**From:** Planning (Isles of Scilly)  
**Subject:** FW: 21185 Carn Thomas - Response to drainage comments

**From:** Marcus Fylan-Smith  
**Sent:** 05 September 2024 10:42  
**To:** Olivia Rickman  
**Cc:** Stella New, Simon Jones; Robin Thorn; Paul Marino; Lisa Walton  
**Subject:** FW: 21185 Carn Thomas - Response to drainage comments

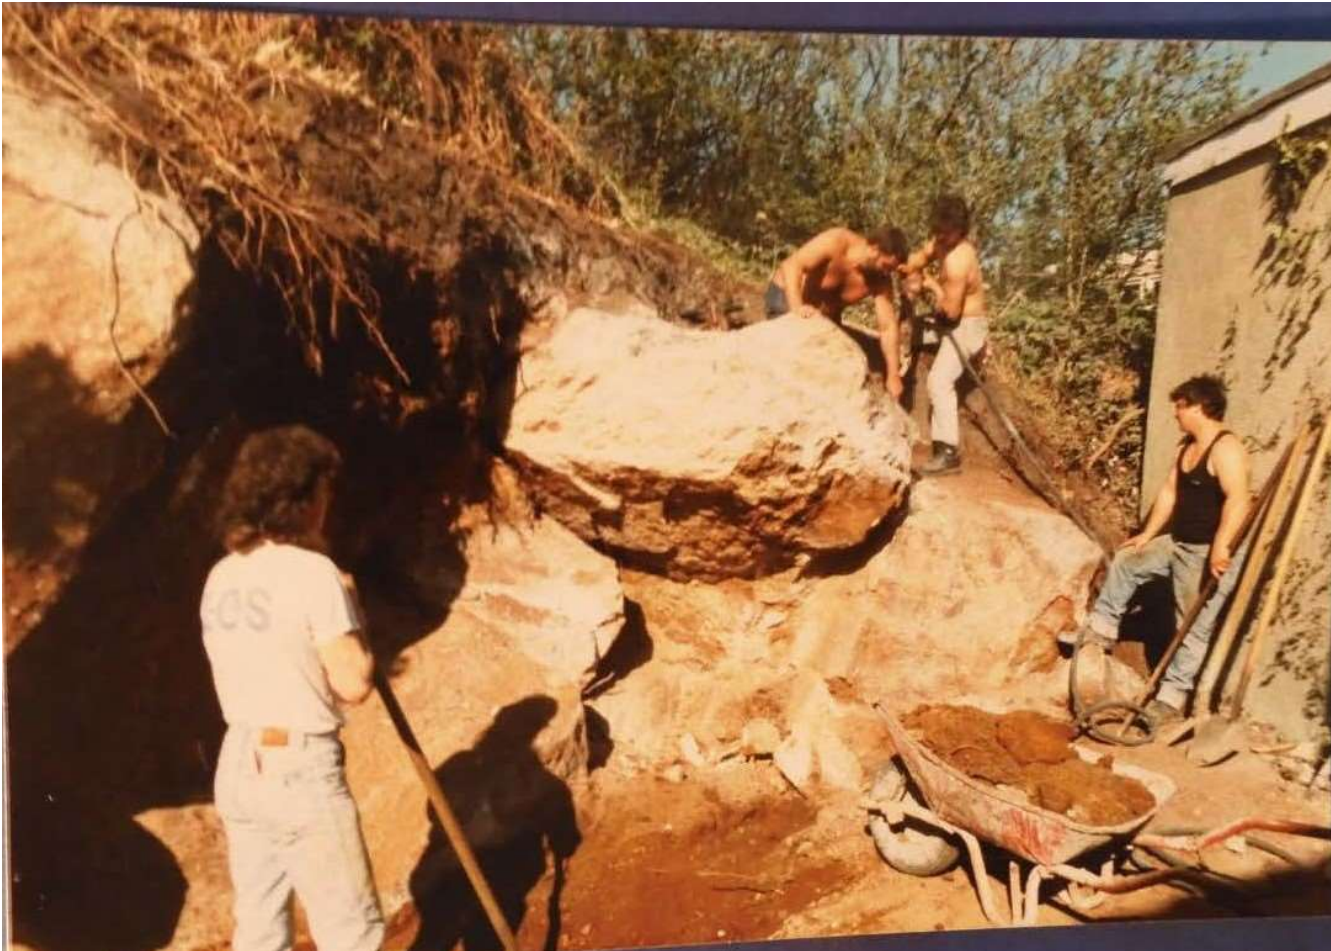
Please see below responses to the drainage queries. Many of them remain the same as before the meeting because we've not had contact with the SuDs representative regarding the original responses.

The drainage proposals have been revised following the information provided by Eddie Williams regarding the existing surface water network and outfall position. All surface water drainage has now been directed to the new outfall pipe location. This has meant the addition of 2 extra inspection chambers, 2 extra manholes and associated pipework. **It is understood that the existing surface water network which drains the road and currently drains from SWMH 3 to G2 to G1 and to the outfall, will now be intercepted between SWMH 3 and G2 and a new 150mm pipe will be laid with new manholes S1.005, S1.004, S1.003, S1.002 and S1.001 to the outfall. It is not clear how far this pipe will extend along the slip way and the beach and whether permission has been obtained by the landowner, to lay this pipework to the desired outfall location. Robin has addressed this comment in his email. I will add his response here for ease. Regarding placing of pipework close to the slip way and the beach we have not yet obtained permission of the landowner, to lay this pipework to the desired outfall location. However, as part of LiveWest's approval process we need to obtain the written consent of the Duchy of Cornwall who benefit from a restrictive covenant on the development site, as does the Ios Council. I appreciate it is presumptuous and not a forgone conclusion, but by working together, we would hope to obtain permission of the Council and Duchy of Cornwall as landowners to deliver the affordable homes including procuring requisite permissions and street works licences to lay any new drains.**

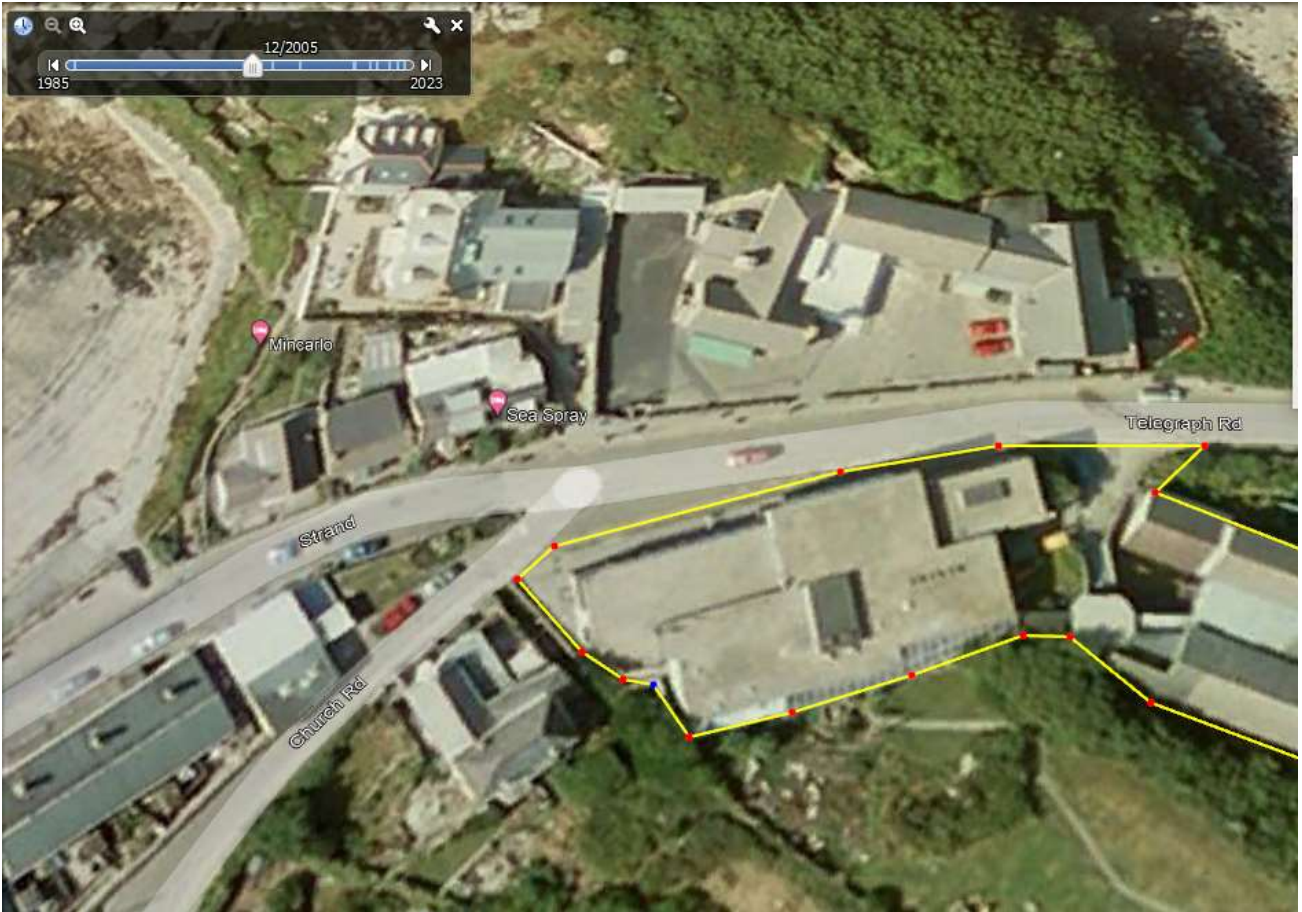
Yes it has. Please refer to FRA. We also attach again a copy of InfoDrainage calculations. **The FRA and the Info Drainage Calculations are not clear on what is the actual impermeable area on the proposed site and what is the 10% urban creep. Could this be provided in terms of m2 please? It is noted that in section 5.7 in the FRA that 10% will be added.**

Total Impermeable Area on Site - 1560m<sup>2</sup>  
 Total Impermeable Area on Site + 10% (Urban Creep) - 1710m<sup>2</sup>  
 Road Impermeable Area draining to the gullies G1, G2, G3 – 1410m<sup>2</sup>  
 Total Impermeable area in model – 3120m<sup>2</sup> (1710 + 1410)

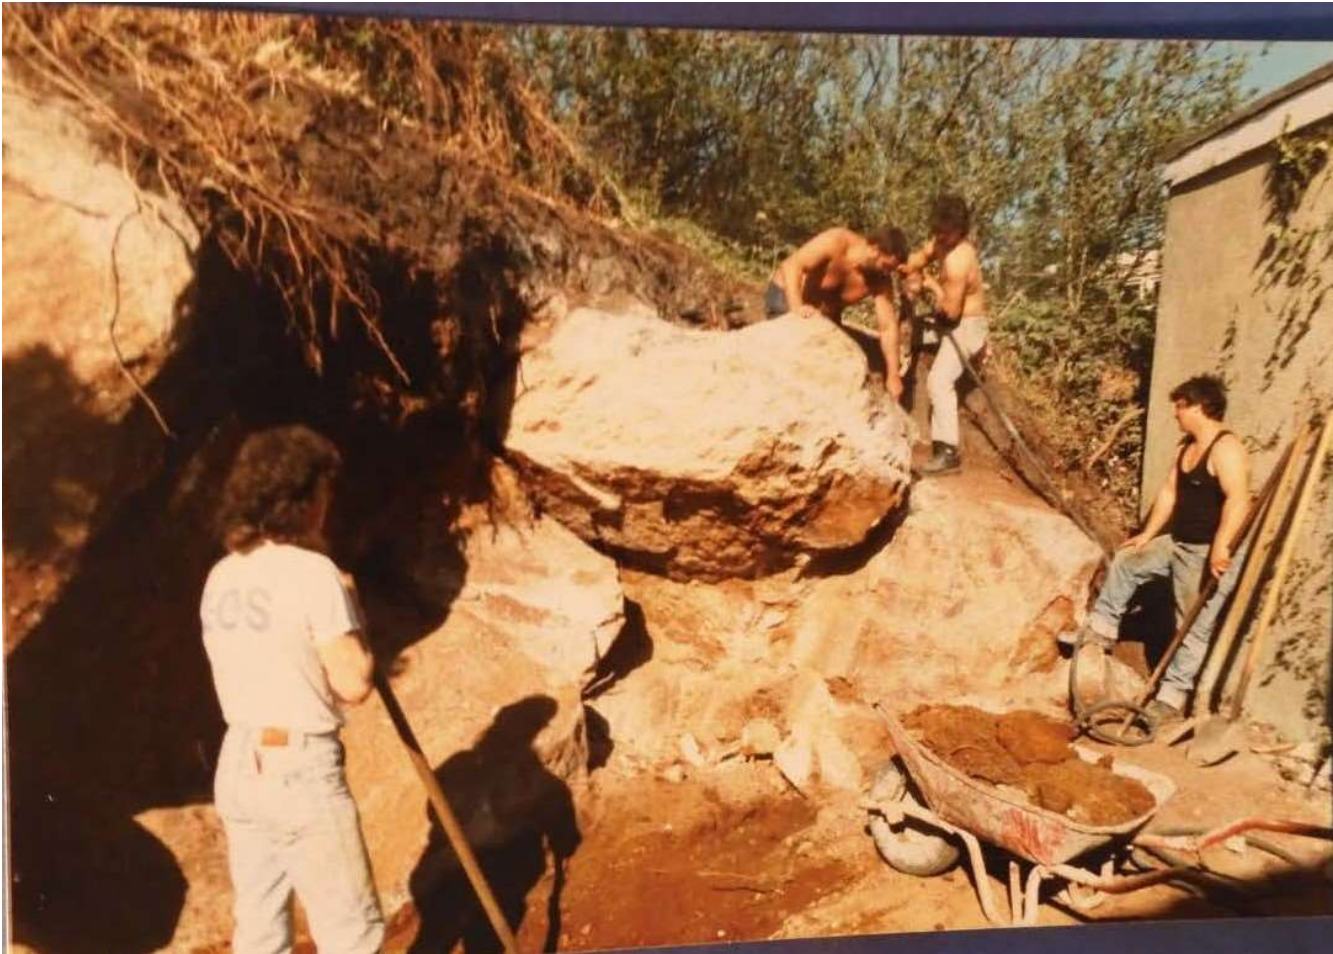
Please see below responses to the drainage queries. Many of them remain the same as before the meeting because we've not had contact with the SuDs representative regarding the original responses.

The drainage proposals have been revised following the information provided by Eddie Williams regarding the existing surface water network and outfall position. All surface water drainage has now been directed to the new outfall pipe location. This has meant the addition of 2 extra inspection chambers, 2 extra manholes and associated pipework. **It is understood that the existing surface water network which drains the road and currently drains from SWMH 3 to G2 to G1 and to the outfall, will now be intercepted between SWMH 3 and G2 and a new 150mm pipe will be laid with new manholes S1.005, S1.004, S1.003, S1.002 and S1.001 to the outfall. It is not clear how far this pipe will extend along the slip way and the beach and whether permission has been obtained by the landowner, to lay this pipework to the desired outfall location.**
